26-056 DT12 Oil Plug Ports

TSB-26-056-FTL

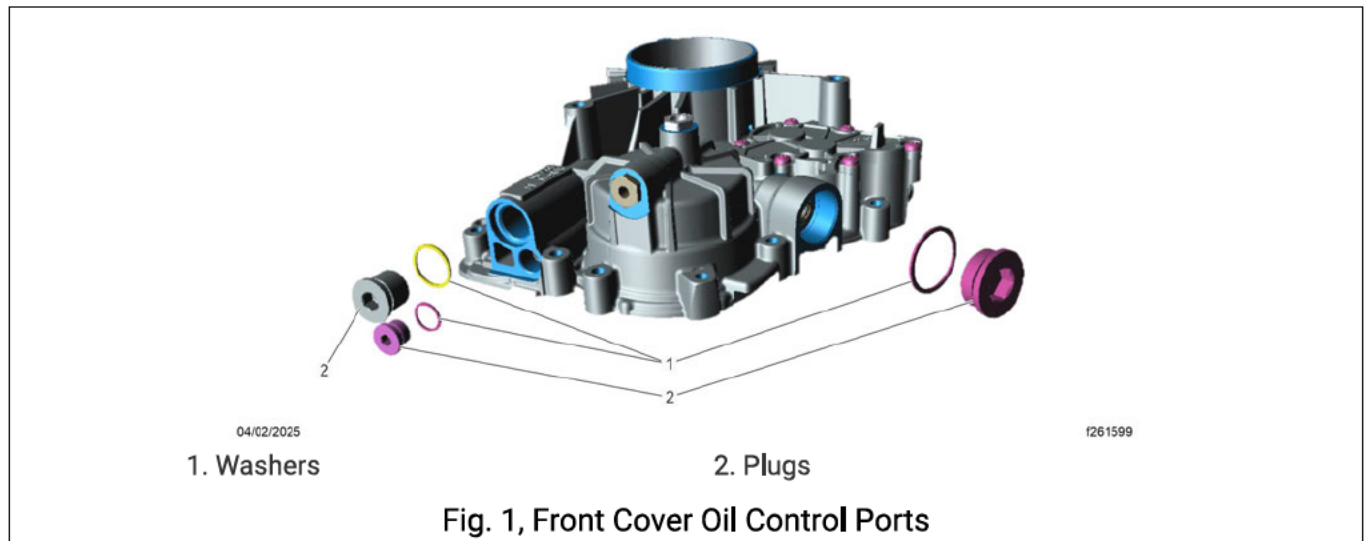
Starting in 2024, new production DT12 C/D-box transmissions have an updated sealing solution for the oil control port plugs on the front cover. The old solution used plugs with crush washers, as shown in Fig. 1. The new solution uses different plugs with pre-applied, or field-applied sealant. The update will happen for each port plug at different times. Depending on the build date, it is expected to find transmissions with one, two, and eventually all three updated plugs.

The new plugs with sealant have different dimensions and are not compatible with the crush washers. The additional thickness of the crush washer changes the position of the thermal and pressure springs used to control the valves.

During the service on these plugs, use seal rings for the plugs designed to have them, or use the newer plugs with the pre-applied sealant. The seal rings must never be added to the plugs that are designed to be used without them.
